## Addendum #1

24 April 2023

**Waterville Armory Roof Repair Project, 74 Drummond Road, Waterville, Maine, DFE Project Number 23SR23-406-D, BGS Project Number 3625, Bid Number 23-028.**

SHEET ID:  
**G-001**  
SHEET: 1 OF 10

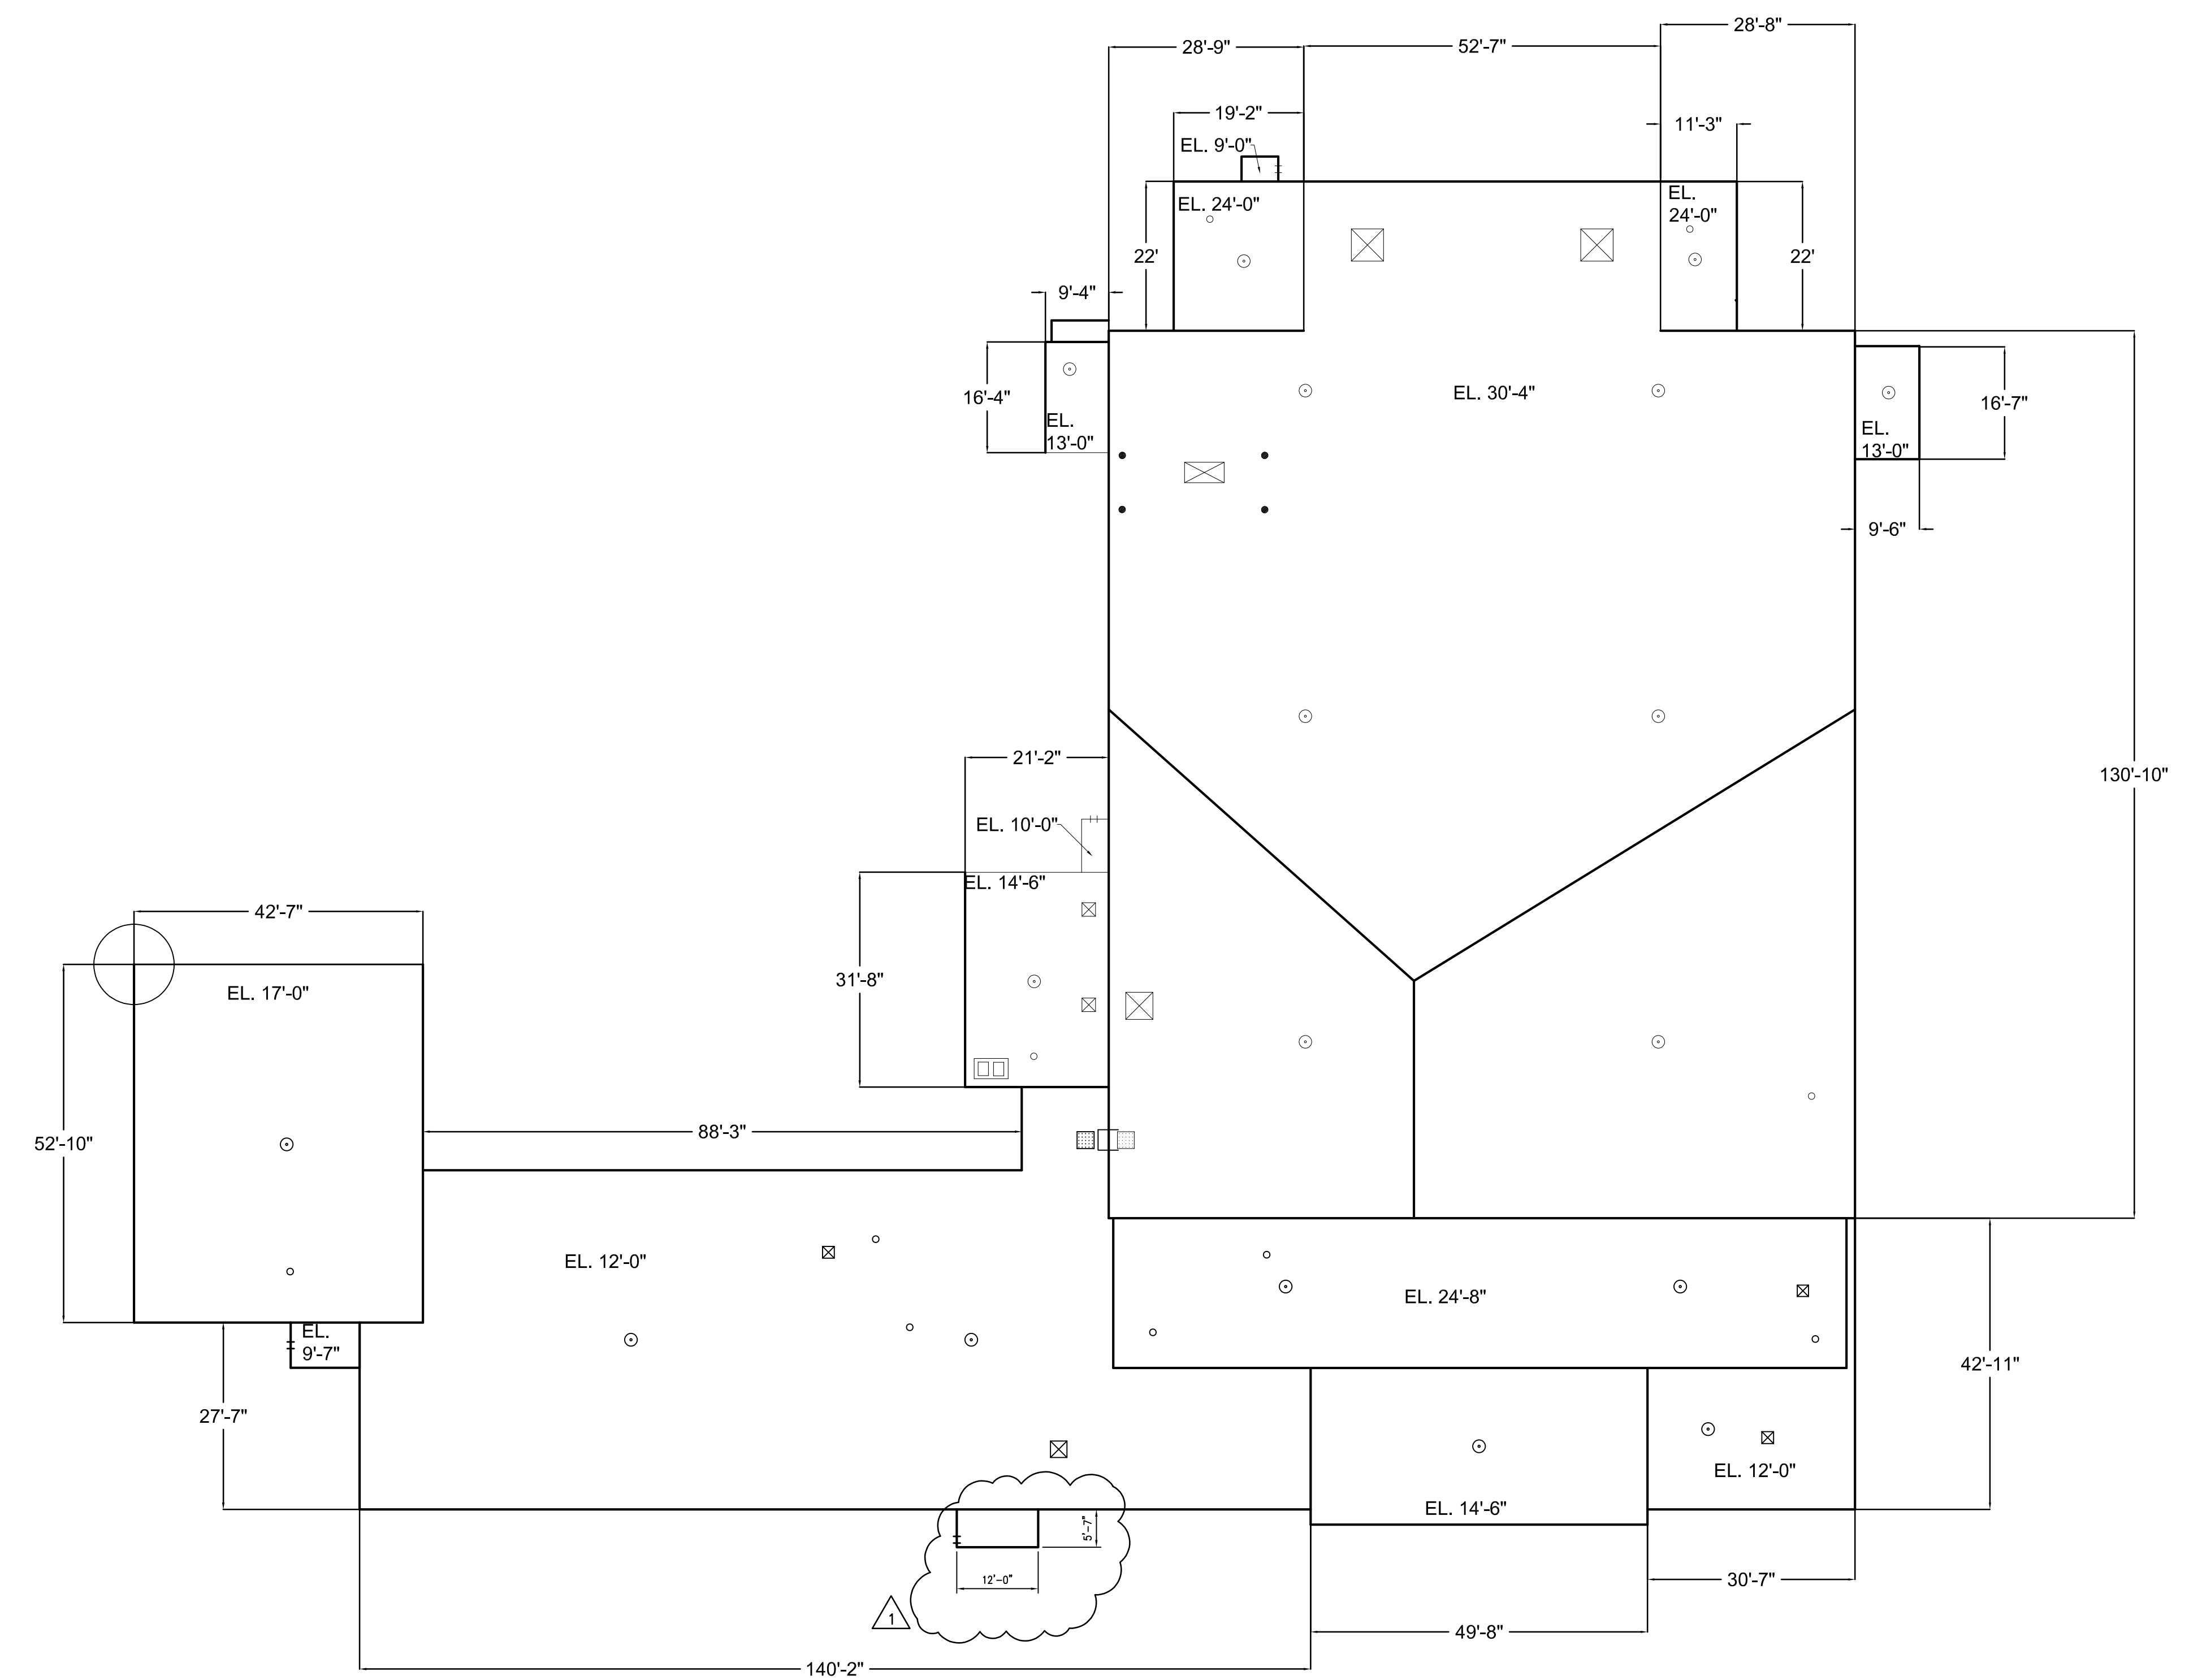
1. Replace Drawing Sheet G-001 – Cover Sheet, with new revised Drawings Sheet G-001 – Cover Sheet. ABI #6 Roof Area #12 has been added.
2. Replace Drawing Sheet S-101 – Existing Roof Framing Reinforcement Plan, with new revised Drawings Sheet S-101 – Existing Roof Framing Reinforcement Plan. ABI #6 Roof Area #12 has been added.
3. Replace Drawing Sheet R-101 – Existing Roof Plan, with new revised Drawings Sheet R-101 – Existing Roof Plan. ABI #6 Roof Area #12 has been added.
4. Replace Drawing Sheet R-102 – Existing Tapered Insulation Plan, with new revised Drawings Sheet R-102 – Existing Tapered Insulation Plan. ABI #6 Roof Area #12 has been added.
5. Replace Drawing Sheet R-103 – Proposed New Roof Plan, with new revised Drawings Sheet R-103 – Proposed New Roof Plan. ABI #6 Roof Area #12 has been added.
